37/3-95 C 7417 Baltimore Avenue
Takoma Park Historic District

7417 Baltimore Ave
Takoma Park

We, the residents of Cleveland and nearby Baltimore Avenues wish to respond to the application for revision of the approved plans for 7417 Baltimore Avenue, Takoma Park (HPC Case 37/3-95C REVISION)

ORIGINAL APPROVED DESIGN

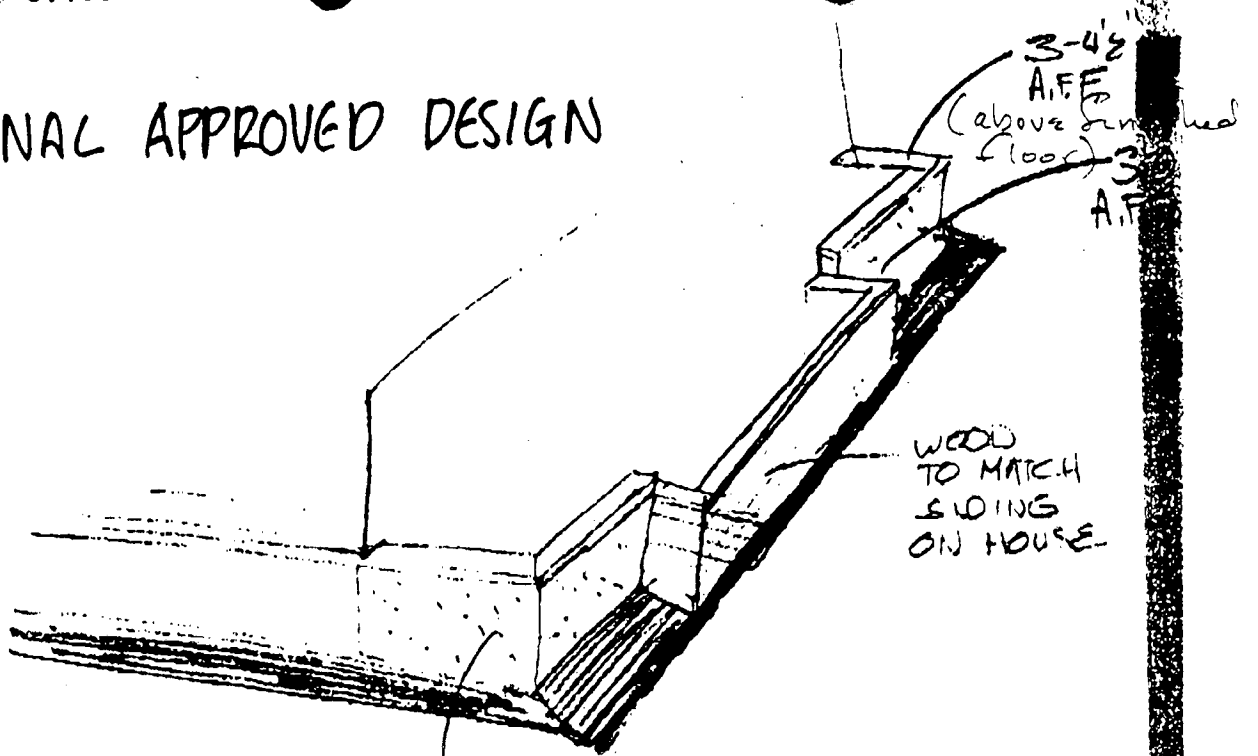
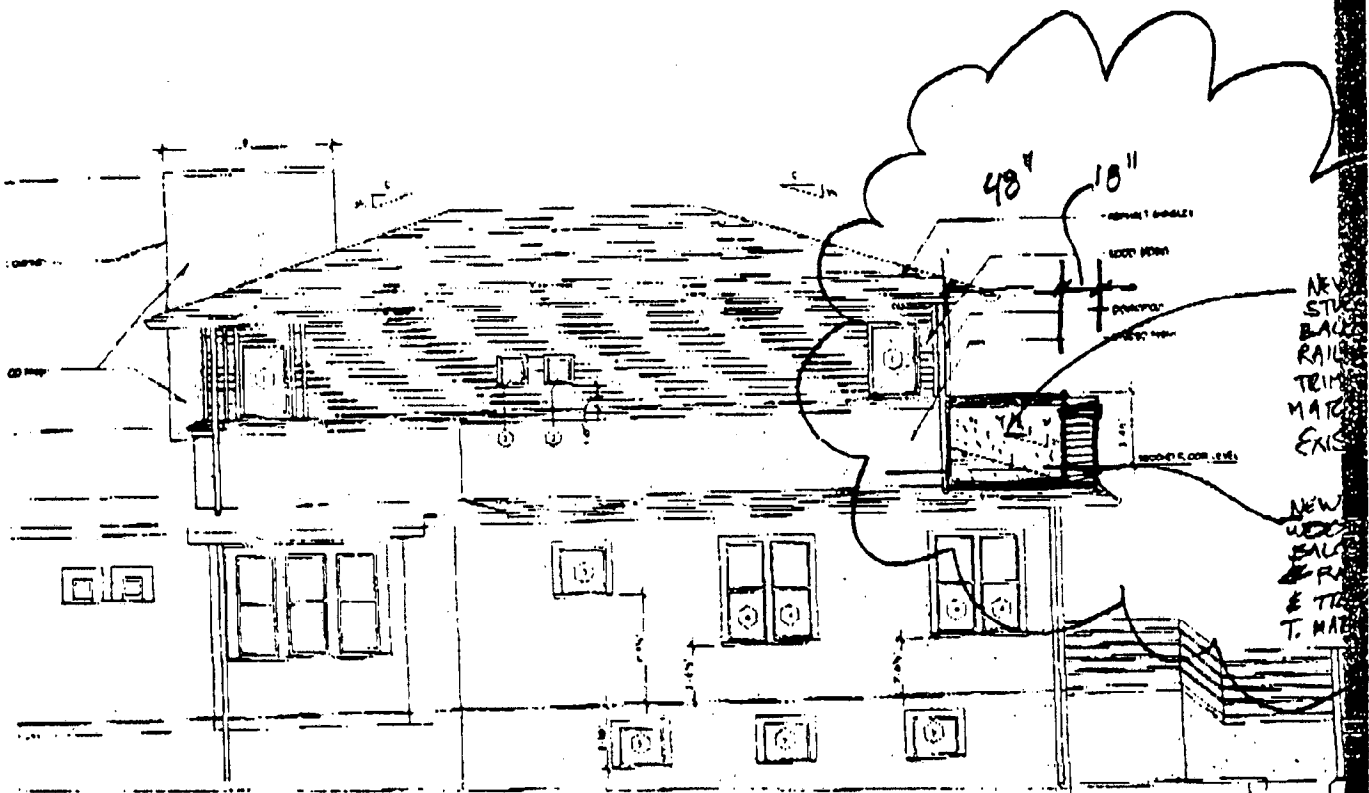
In Mr. Calloway's case, the design which had originally been prepared for the balcony revision - for an inset balcony with lapped siding on the center of the balcony railing and with stucco siding at each end - was considered by the Commissioners as more appropriate an addition to your handsome Prairie-style house than the revised design submitted by Mr. Calloway's building contractor.

The proposed design of the second story deck is, for this reason, a problem. The initial balcony design was prepared by George Kousoulas and was sent to the applicant (See Original Approved Design). In this design, integration of the balcony into the first floor hipped roof kept the roofline, which runs from the front of the original resource, in a well reasoned line around the rear of the new addition. In effect, the roofline of the original house in the architect's design controlled the overall line of the combined old/new house. The long horizontal line brought the eye back to the old house. It also served the important function of anchoring the large vertical mass of the new addition.

The revised plan submitted by the builder, in staff's opinion, bears no relation to a Prairie style house in general, nor to the historic resource which is to be preserved. The proposed squared-off deck with a wood slat railing, is more in keeping with contemporary tract housing than with an effort to integrate the balcony into the overall Prairie design of the historic house.

6) 2nd story balcony revision not approved. Balcony must be built per original plan as approved.

ORIGINAL APPROVED DESIGN

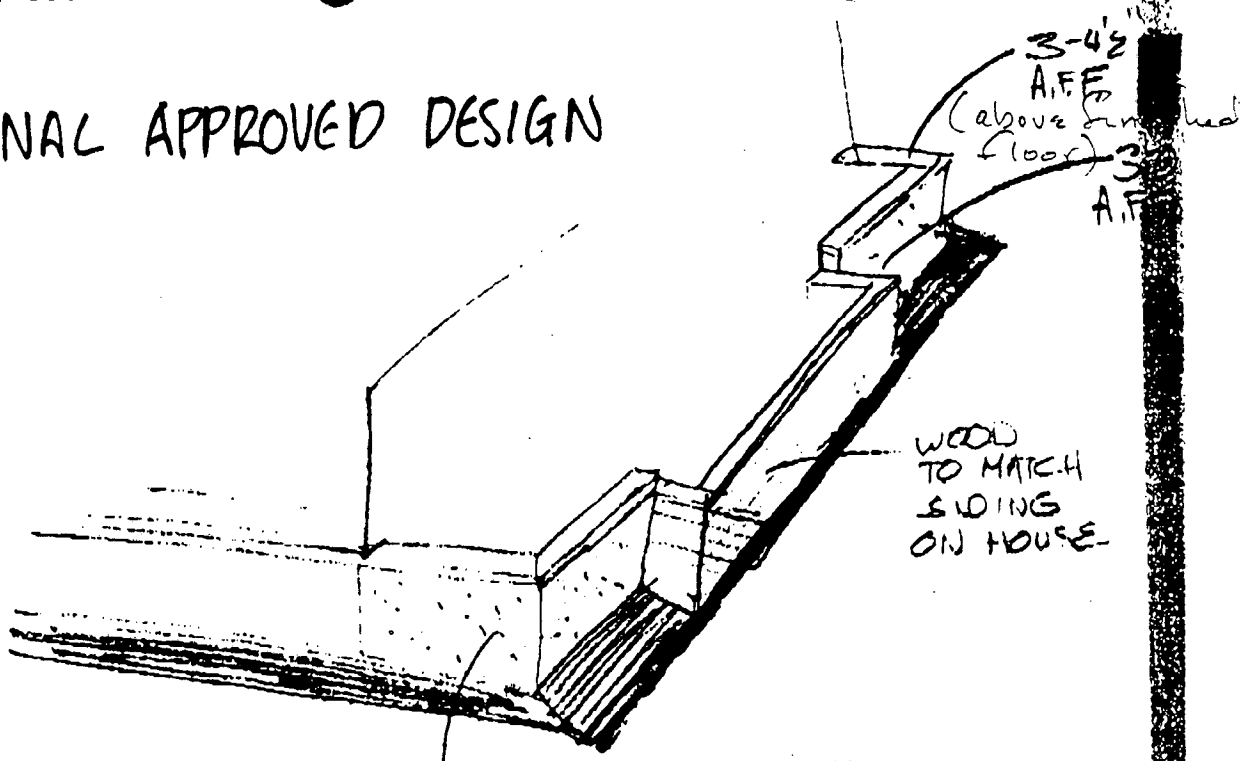
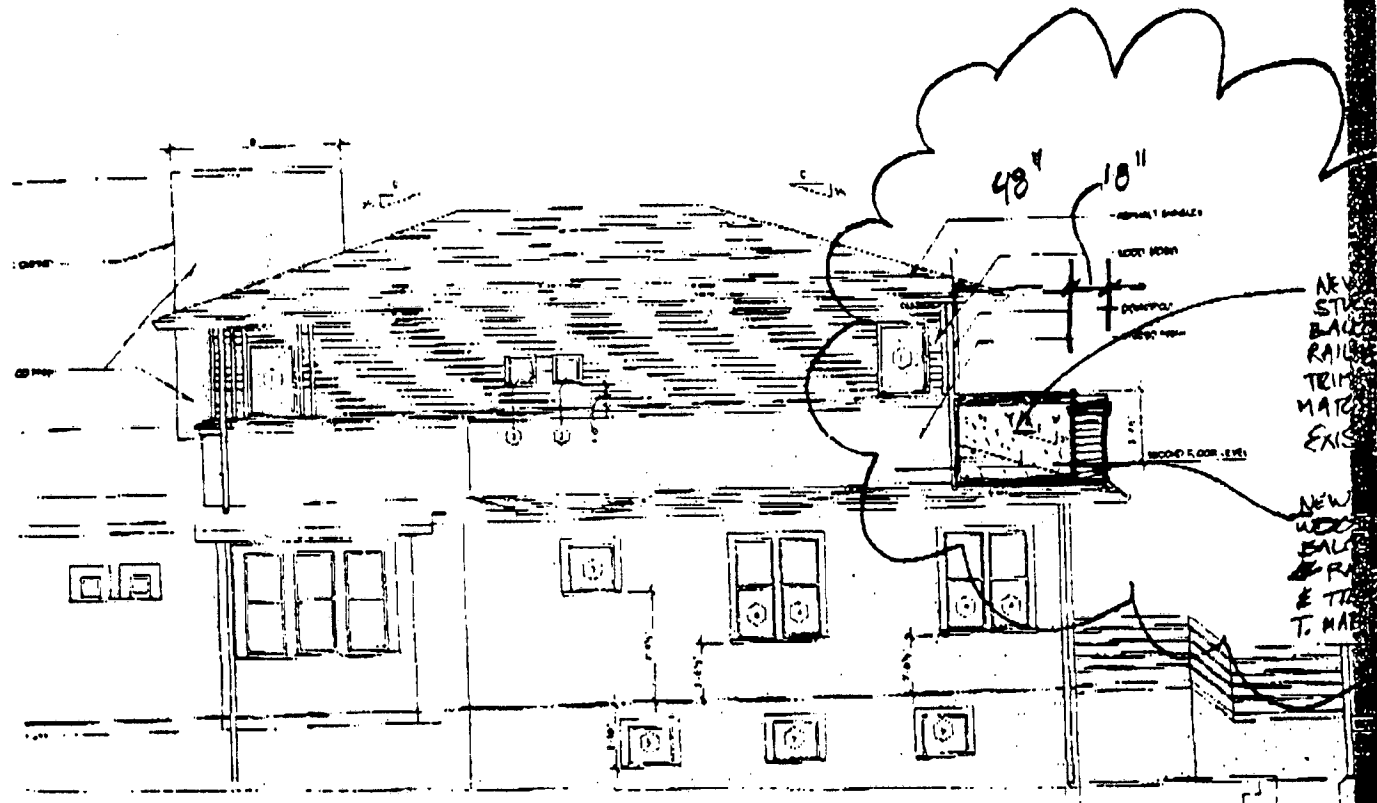
A second problem with the proposal is the railing detail that is definitely not appropriate or compatible. It is not clear to staff why the slat railing is being proposed instead of using a lapped siding covered frame railing as was originally designed. In both designs for the wood section, a gap at the bottom of the wood facing would provide drainage for the balcony. However, the siding railing serves an important purpose as it allows the railing to visually recede into the siding of the second story, thus relating the balcony to the second story. The proposed use of slats, on the other hand is a visually heavy treatment that is completely unrelated to any other aspect of the addition or of the original resource. It should be emphasized that HPC's approval of a two-level deck (with a railing of lapped siding) on the first floor has been reaffirmed at the January 8, 1997 meeting, and, as approved, it must be built, with lapped siding, not layered spaced slats.

The 2nd story deck as constructed is not as successful as it would have been if built to the original agreed-upon design. It is a less interesting design than the pocket porch originally planned to be placed within the hipped roofline. However, the use of both stucco and horizontal siding for the railing is, in staff's opinion, a reasonable means of avoiding the look of an Art Moderne deck, and this existing 2nd story deck should be approved as long as the railing is built as specified.

PROPOSED SOUTH ELEVATION

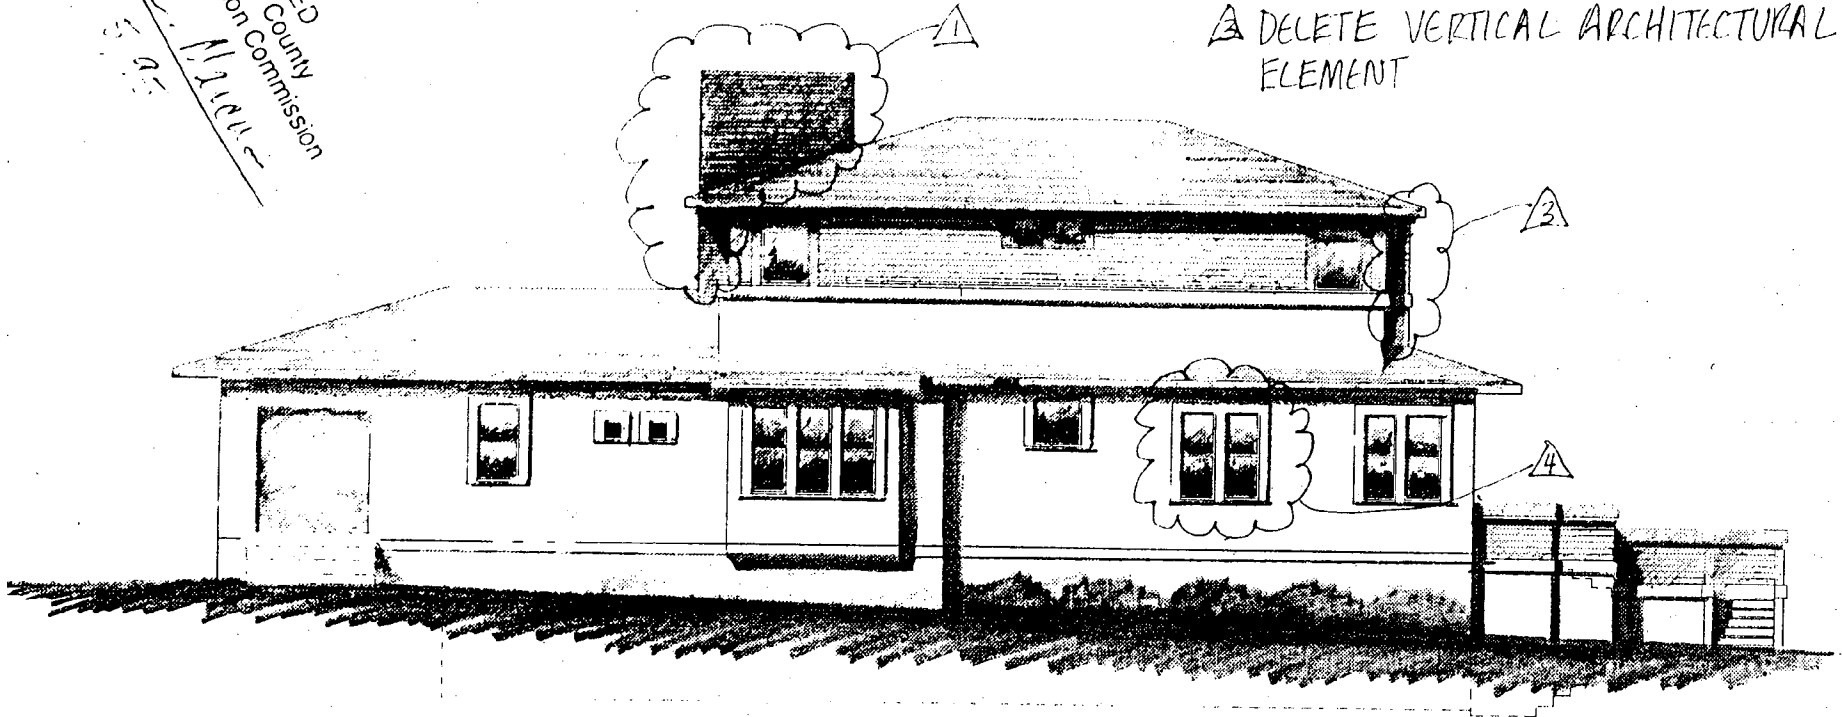
△ FRONT CHIMNEY TO HAVE "STUCCO" FINISH

△ SHORTEN LENGTH OF DOUBLE WINDOW

△ DELETE VERTICAL ARCHITECTURAL ELEMENT

PROPOSED SOUTH ELEVATION

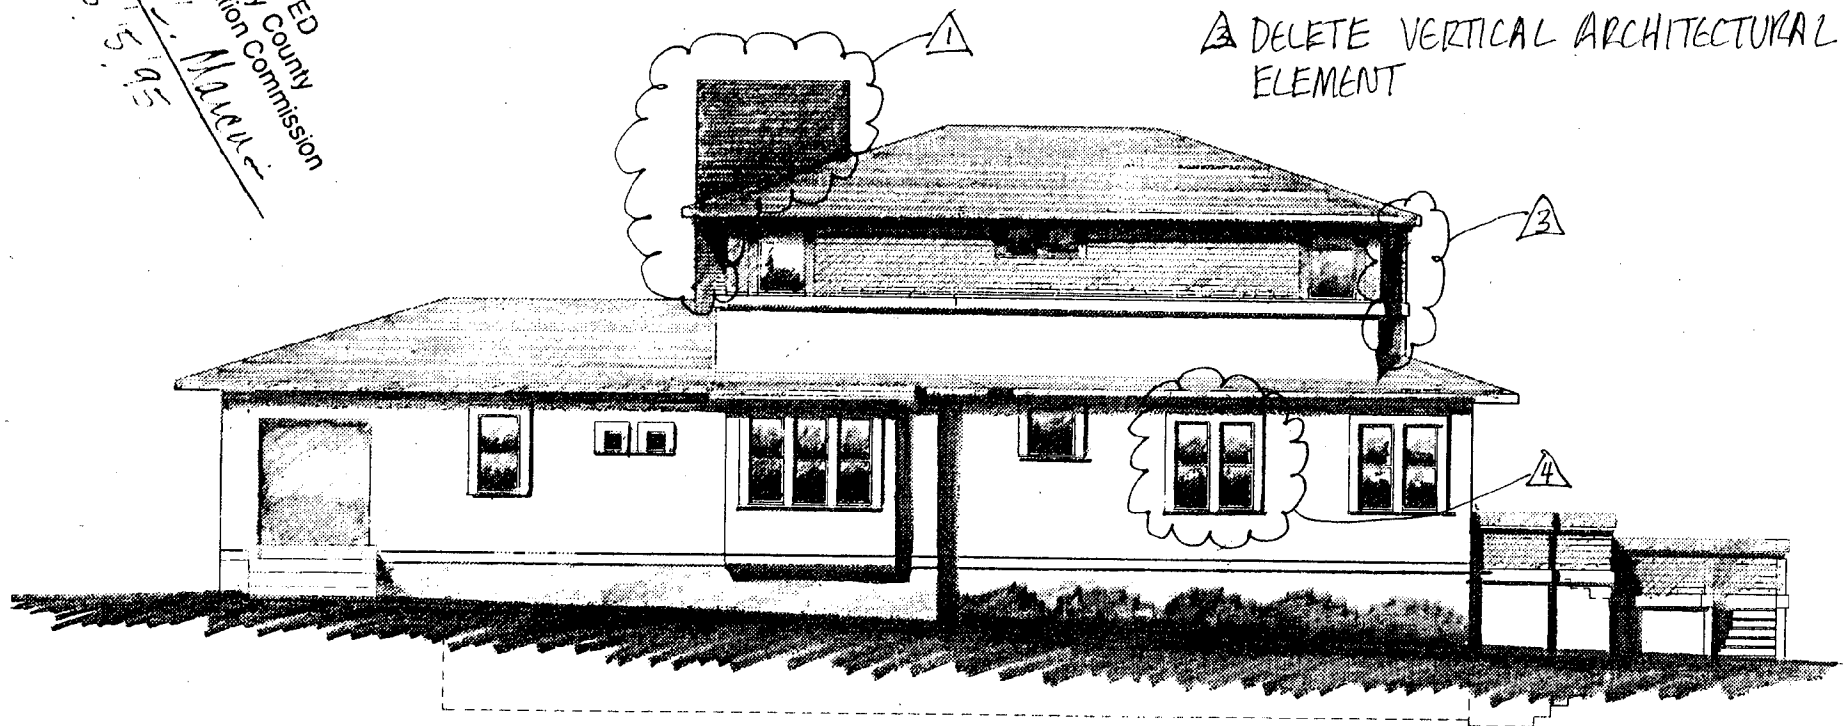
△ FRONT CHIMNEY TO HAVE "STUCCO" FINISH

△ SHORTEN LENGTH OF DOUBLE WINDOW

△ DELETE VERTICAL ARCHITECTURAL ELEMENT

PROPOSED NORTH ELEVATION

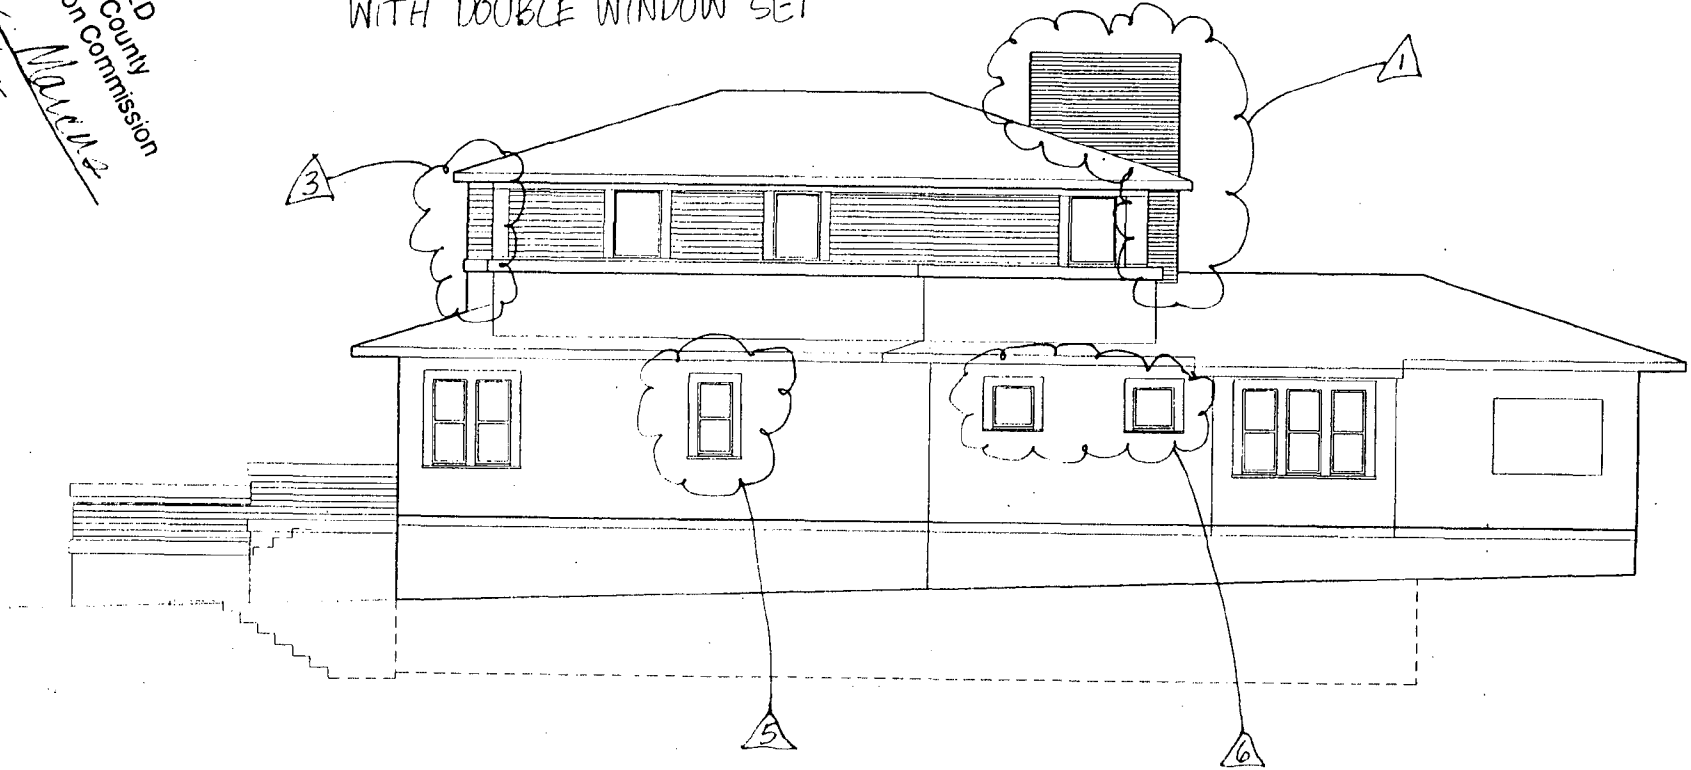
- 1 FRONT CHIMNEY TO HAVE "STUCCO" FINISH
- 2 DELETE VERTICAL ARCHITECTURAL ELEMENT
- 3 SHIFT WINDOW TO WEST AND SHORTEN
- 4 DELETE 2 SHORT WINDOWS / REPLACE WITH DOUBLE WINDOW SET

PROPOSED WEST ELEVATION

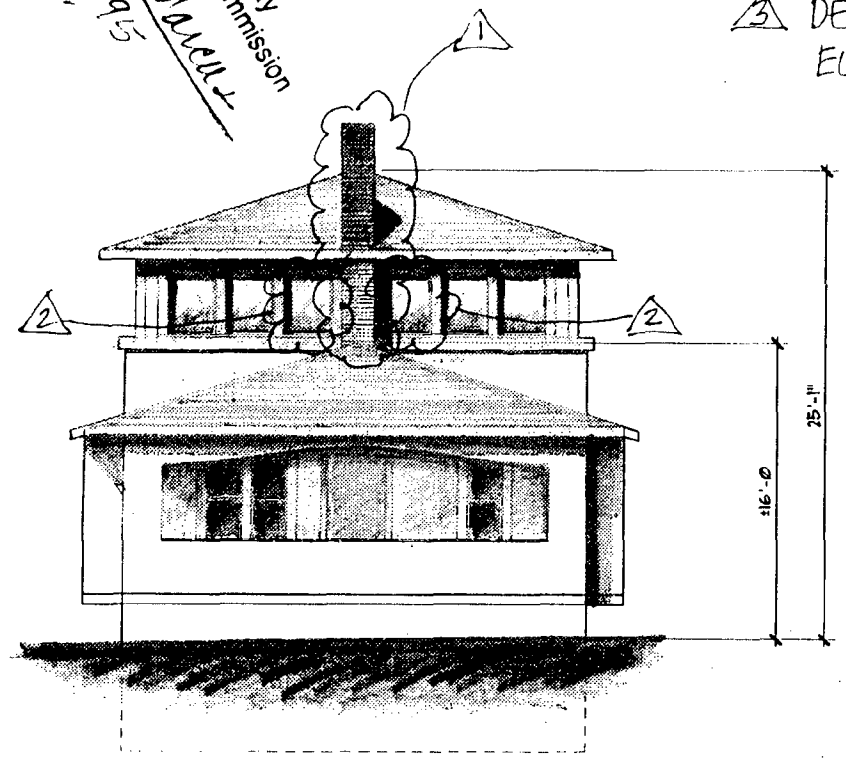
- △ FRONT CHIMNEY TO HAVE "STUCCO" FINISH
- △ DELETE WINDOW
- △ DELETE VERTICAL ARCHITECTURAL ELEMENT

12/20/96 FRONT FACADE - PROPOSED
NOT TO SCALE

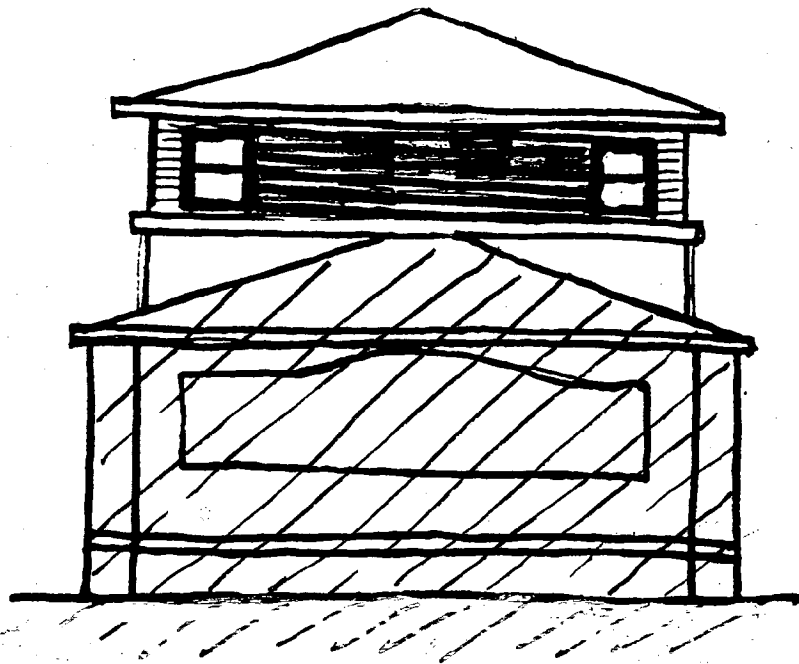
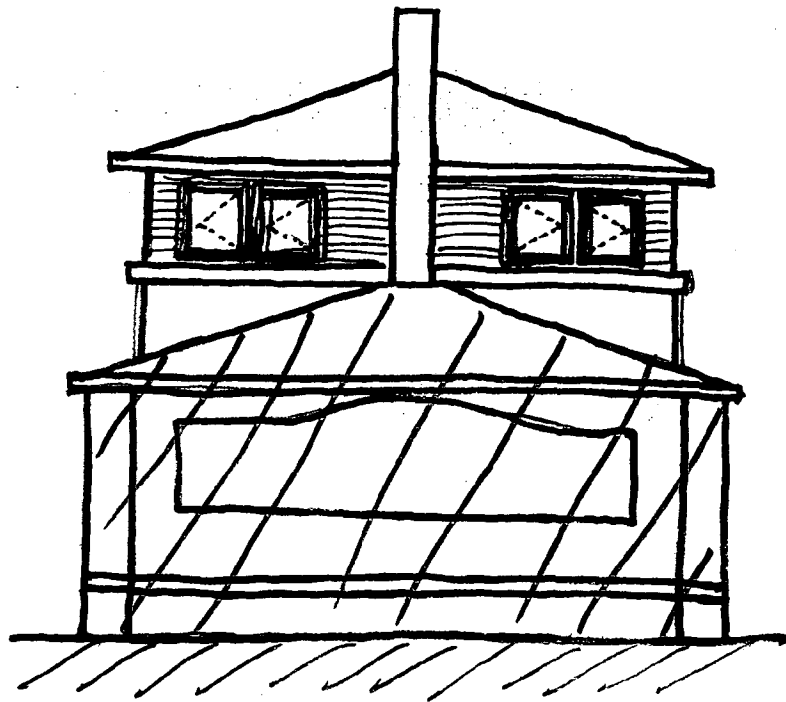
Staff would also not support the deletion of the chimney block. Typically, the horizontal lines of Prairie style houses would be interrupted by vertical elements such as masonry piers or chimneys. Frequently, as in this design, the chimney is placed so that there is a narrow face to the street and a wider plane to the side. The use of the interruption is appropriate to demarcate the dividing line between the old and new sections. The narrow/wide profile fits particularly well into the setting of the house on a long narrow lot.

Delete two inner window closest to roof line and change from casement to double hung as are already being use in the rest of the house (old and new). Also delete the artificial chimney between them entirely due to rising expenses in Job and personal preference. (100000)
also removal of the chimney will keep the low profile look into.

- Deny change to double-hung from casement windows on 2nd story, all facades.
- Deny chimney deletion.
- Deny window deletions on west (front) facade and 2nd story of east facade.
- Deny door change on 2nd story of east (rear) facade.
- Deny use of 24" x 36" window pair on 1st floor of north facade.
- Deny first floor deck modification.
